ADDENDUM 2 GATEWAY

S-1/

STREET ENTRANCE BUILDING & SWEDE ALLEY) Z (HEBER AVE. MOUNTAIN

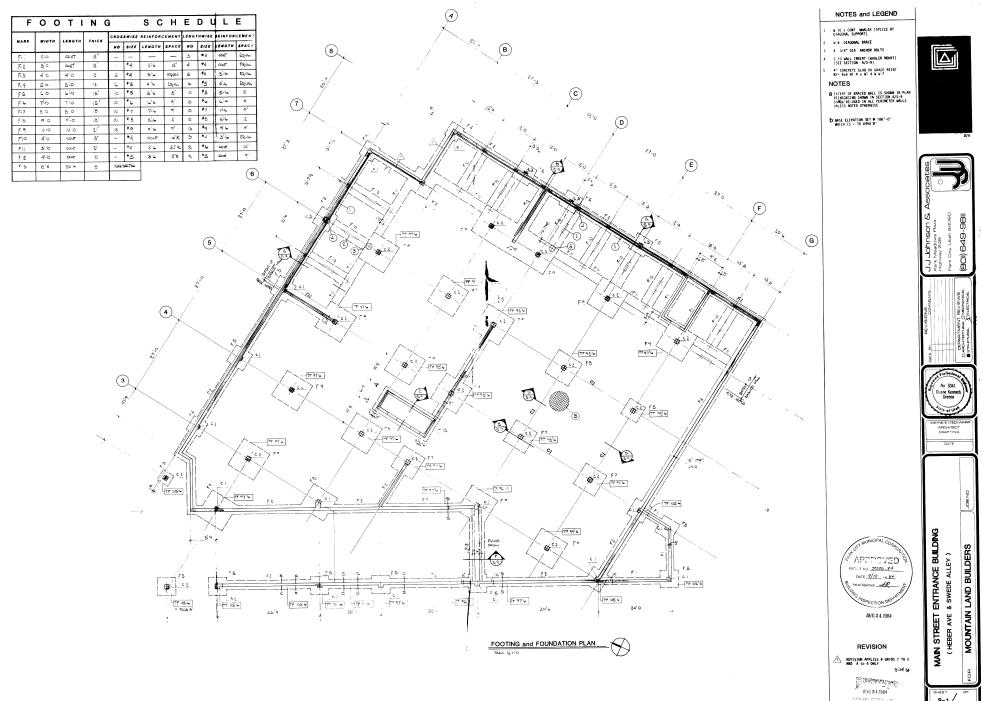
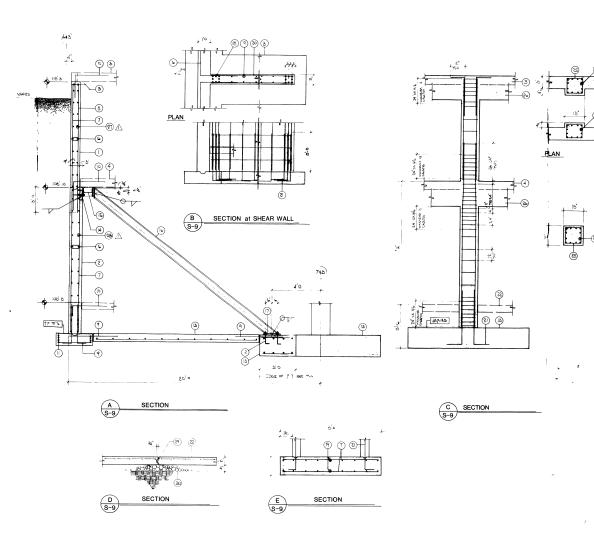
REVISION APPLIES # GRIDS 7 TO 8 CONTRACTOR (CO.) STP 10 1984 - TI PITT DING
